**AGENDA**  
**MONTGOMERY TOWNSHIP**  
**BOARD OF SUPERVISORS**  
**December 16, 2013**

9. Consider Approval of DVRPC Powerline Trail Connector Feasibility Study
10. Consider Preliminary/Final Land Development Plan – LDS#669 Chick-Fil-A
11. Consider Preliminary/Final Conditional Land Development Plan – LDS#666 - Giant to Go

12. Consider Preliminary/Final Conditional Land Development Plan – LDS#663  
Commerce Group
13. Consider Preliminary/Final Land Development Plan – LDS#670 - Montgomery Township  
Community/Recreation Center

Attachment: Reduced Copy of Applicant's Plan

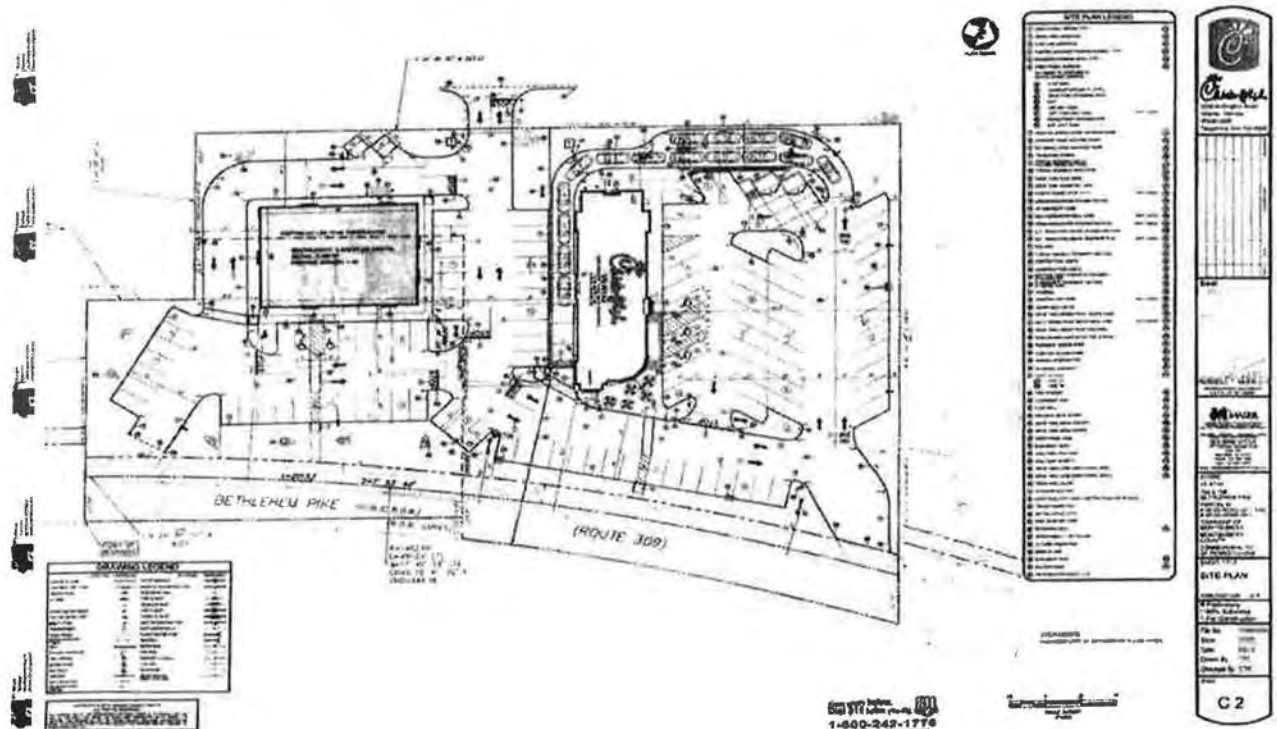
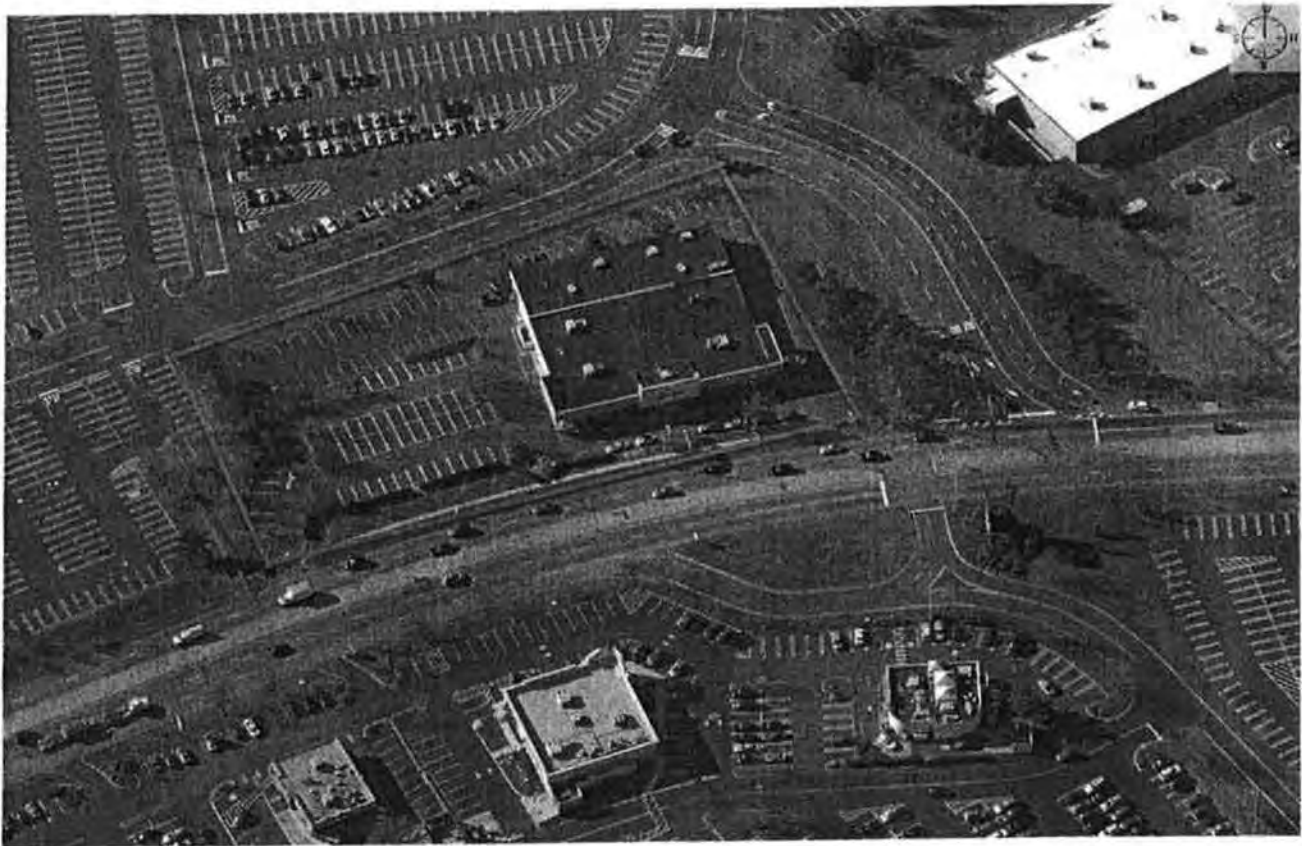
- H. The tree protection fencing details on Sheets L2 and C11 should be revised to state that tree protection fencing shall be located a minimum of 15' from the trunk of the tree or at the dripline, whichever is farther from the tree. Additionally, a note should be added to the detail requiring that the tree protection fencing shall be maintained until all work and construction have been completed. Any damages to tree protection fencing shall be repaired before construction may continue.

- S. Note No. 2 under the Planting Notes under the Landscape Notes on sheet L2 references NJDOT specifications. The plans should be revised to reference only standards and specifications that are appropriate and relevant to Montgomery Township, Pennsylvania.

- T. Note No. 9 under the Maintenance Notes under the Landscape Notes on sheet L2 states that all tree guys and stakes shall be removed by the contractor 1 year after final acceptance. As a significant amount of damage can be caused to trees by leaving stakes and guys installed for too long, we recommend that tree stakes be removed after the first full growing season after planting. The note should be revised to require removal of the tree stakes at this time.
- U. It appears that some of the wording within Notes No. 1 and 2 under the Tree Protection Specifications has been mixed up. The notes should be revised for clarity.
- V. A detailed response letter addressing the above noted comments and any other changes to the plans should be included with future submissions.

### Reduction of Applicant's Proposed Plan

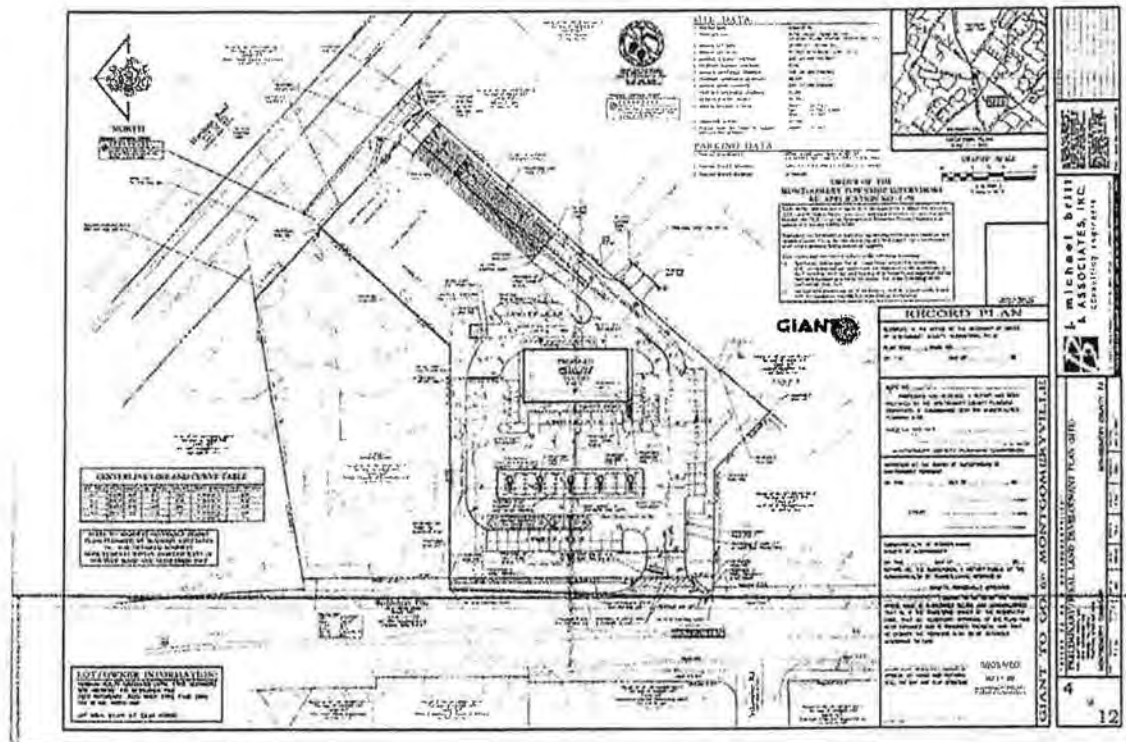
- J. The Rain Garden impoundment details call for the installation of approximately 3" of mulch. This appears to conflict with the Rain Garden Seed Mix installation specifications on sheet LP-2, which calls for the installation of seed on a bare soilbed. The plans should be revised to correct this discrepancy.
